BARCLAY MEDICAL OFFICE BUILDING

SP# 04-22

STAFF REPORT

April 13, 2022

CAPE COD BERM

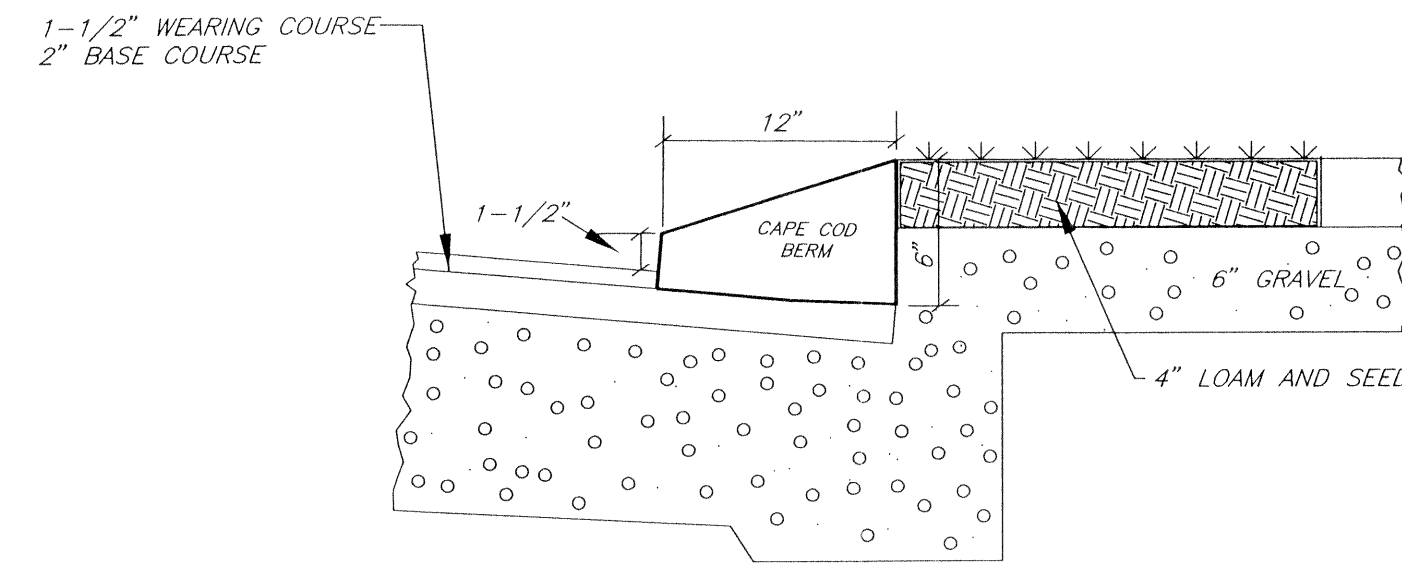
- a. The applicant has shown a one-inch bituminous sidewalk next to the cap cod berm in the detail but has not shown this sidewalk on the plan set. The applicant should coordinate the detail and plan set.
- b. ETGTD Section 565.1.1. The applicant is reminded of Town of Hudson requirements for the importing of off-site fill materials for use in constructing this project. It is recommended that these requirements be stated on the plans for the Contractors attention.
- c. The applicant should provide a detail for the walkway area in front of the porch. It is unclear if that area is to be paved or a sidewalk proposed.

11 – a – Site plan governs, details are only illustrative and not required.
b – Not relevant.
c – Level paving.

DOUBLE LEACHING CATCH BASIN

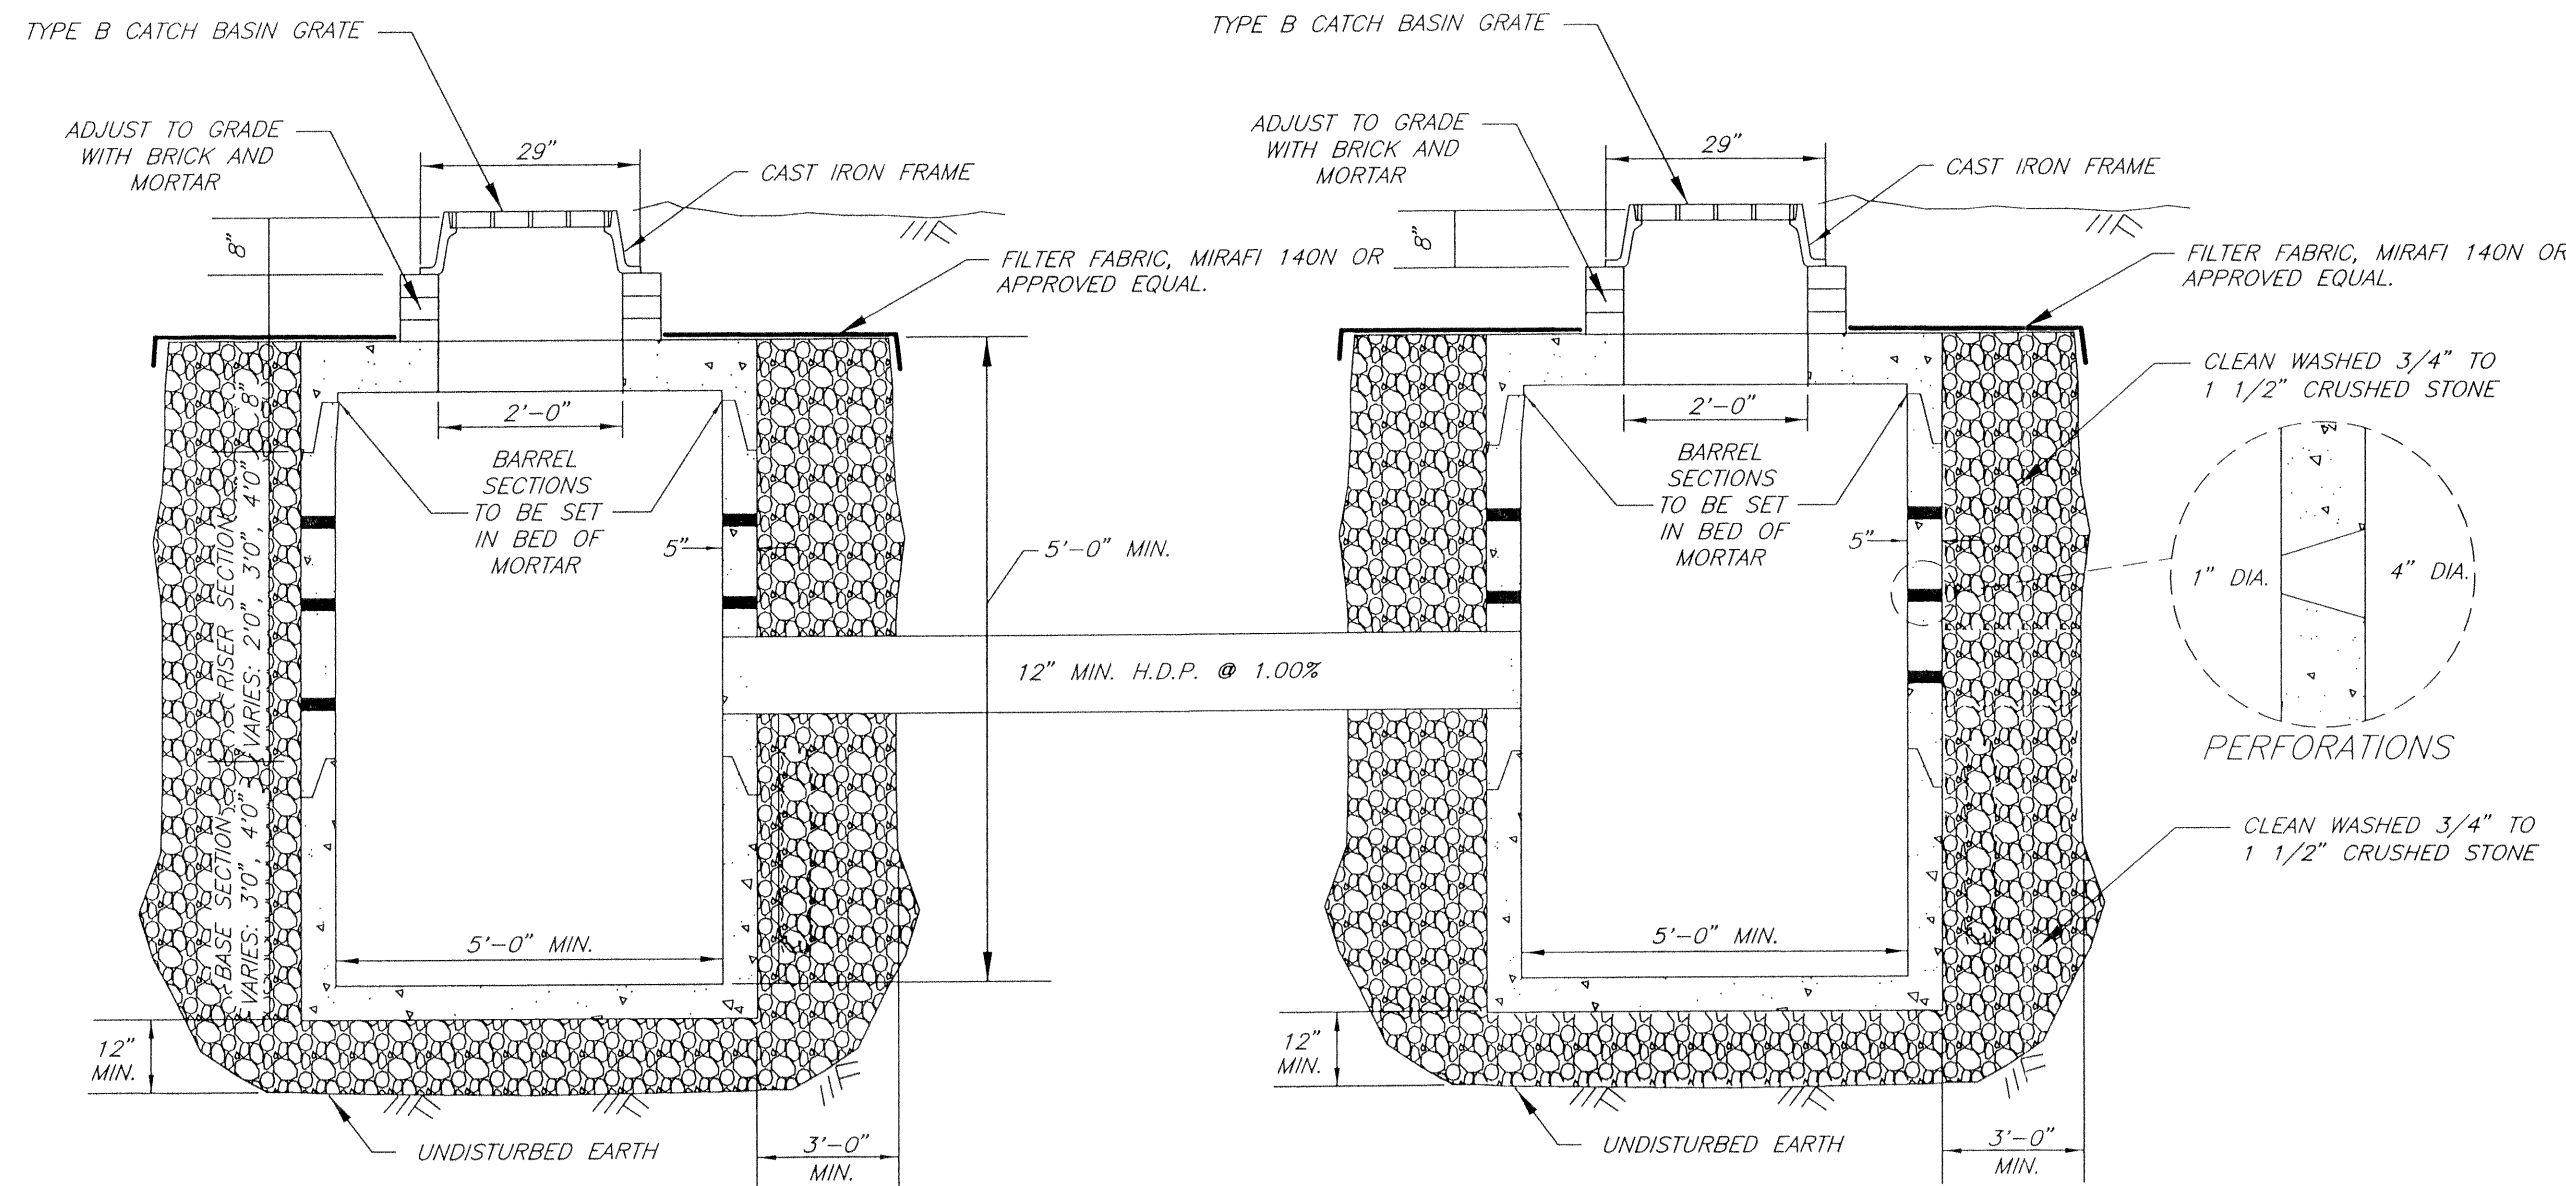
- 2. The HydroCAD calls for a 12' diameter x 6' tall vertical cylinder of stone set at 120.00'. The plan details call for a 5' structure with 3' of stone (11' overall). The applicant should coordinate the plans and the HydroCAD dimensions to match.

- 3. The plan details illustrate the CB sump is a regular structure bottom, while the top riser sections are perforated. The applicant should note this for the contractor to install the correct design.

- 4. The applicant should state on the plan if this 120.0' is the bottom of the basin sump or the bottom of the stone, and clarify if this elevation accounts for the pre-treatment volume of the sump.

- 5. We note the HydroCAD does not utilize the volume of the catch basin within the stone, which would increase volume of the structure.
- j. HR 290-5.A.12, 290-7.A.9. & 290.9. The applicant should provide an I&M manual.

- g – Comment appears irrelevant.
 - h – Not understandable, please amplify.
- 6 – i – 1 – See dwg 3.
 - 2 – Plan detail is over designed.
 - 3 – Noted.
 - 4 – Noted.
